SERVICE INSTRUCTIONS

No. 1175
ATA Code 77-00

SUBJECT: ENGINE INDICATING - MODIFICATION AND CALIBRATION OF AIRCRAFT INSTRUMENT AND DEVELOPMENT INCORPORATED ENGINE INSTRUMENT CLUSTERS

Figure 1

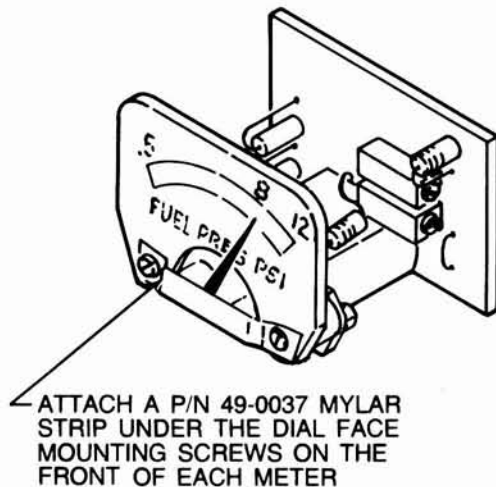
8. Refer to the wiring diagrams in Figures 4, 5 and 6 and repair the engine instrument cluster if required.
9. Prior to reassembling the cluster, remove any and all tape that may be found around the meter movements and on the inside of the face mask. Install P/N 49-0037 mylar strips on the front of each meter movement by securing the strips under the heads of the screws that attach the dial face to the meter movement as shown in Figure 1.

Figure 2
Engine Instrument Cluster Adjustment Points

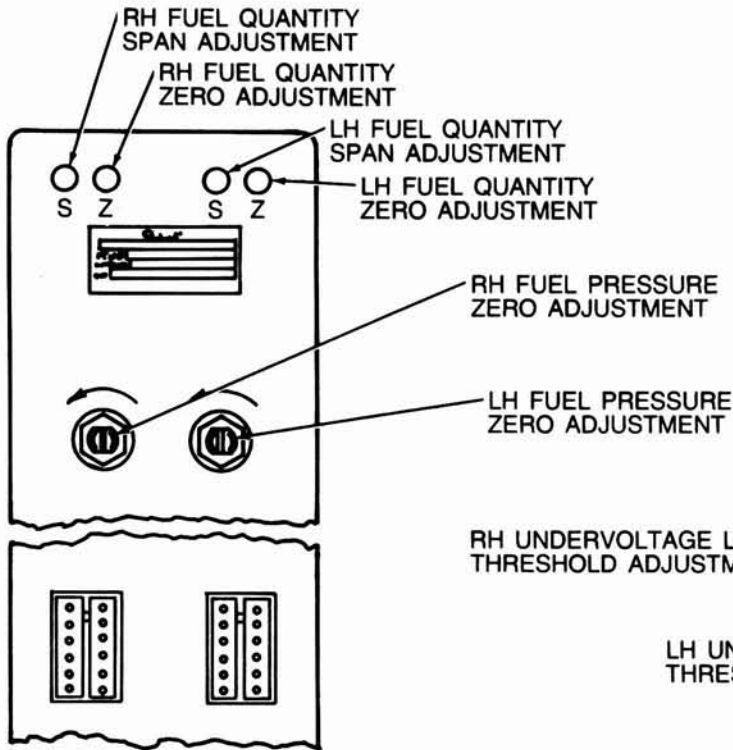
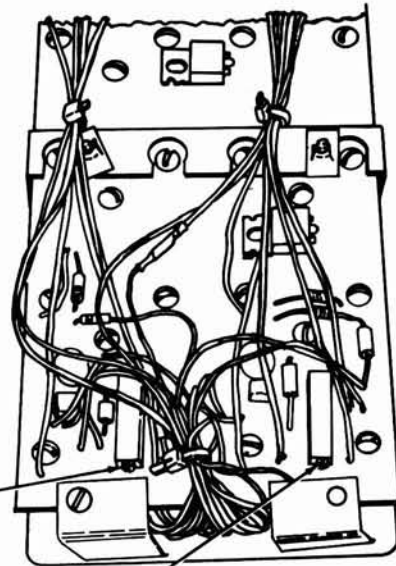
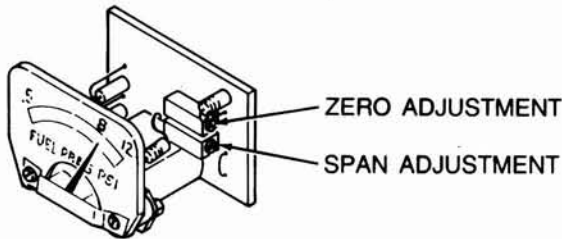
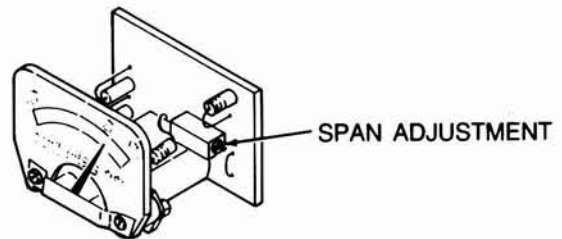
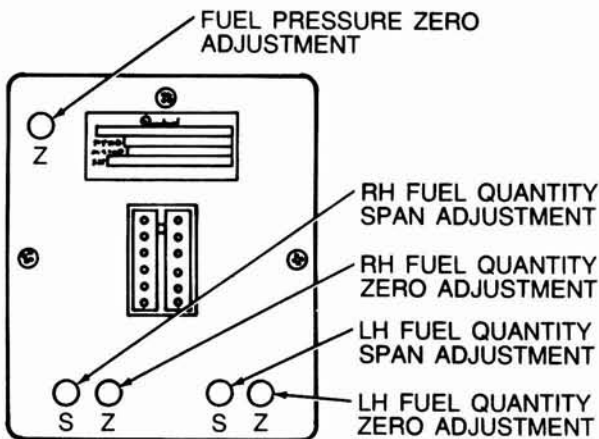
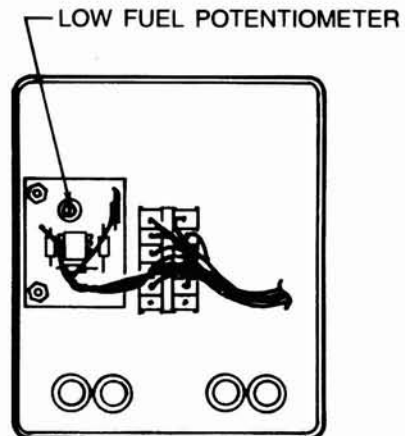
- b. For fuel quantity, fuel pressure, oil pressure, oil temperature and cylinder head temperature indicators, connect the appropriate resistance for the low scale indication as specified in Table 1 between the appropriate pin of the electrical connector (see Table 2) and ground. Adjust the zero (Z) adjustment potentiometer (see Figure 2) so the meter reads at the low scale mark on the meter dial face.

- c. Connect the appropriate resistance for the high scale indication from Table 1 in place of the resistance used in step 11b and adjust the span (S) adjustment potentiometer (see Figure 2) so the meter reads at the high scale mark on the meter dial face.

- e. On P/N 105-389011-5 and 105-389011-31 engine instrument clusters only, connect a variable power supply to pin 11 (see Table 2). Set the voltage at 14 or 28 volts, as applicable, and gradually reduce the voltage until the undervoltage light is illuminated. The light should illuminate at $12.2 \pm .1$ volts on 14 volt clusters and $23.75 \pm .5$ volts on 28 volt clusters. The undervoltage circuit potentiometer (see Figure 2) should be adjusted within these limits. Clockwise increases the voltage at which the light illuminates.
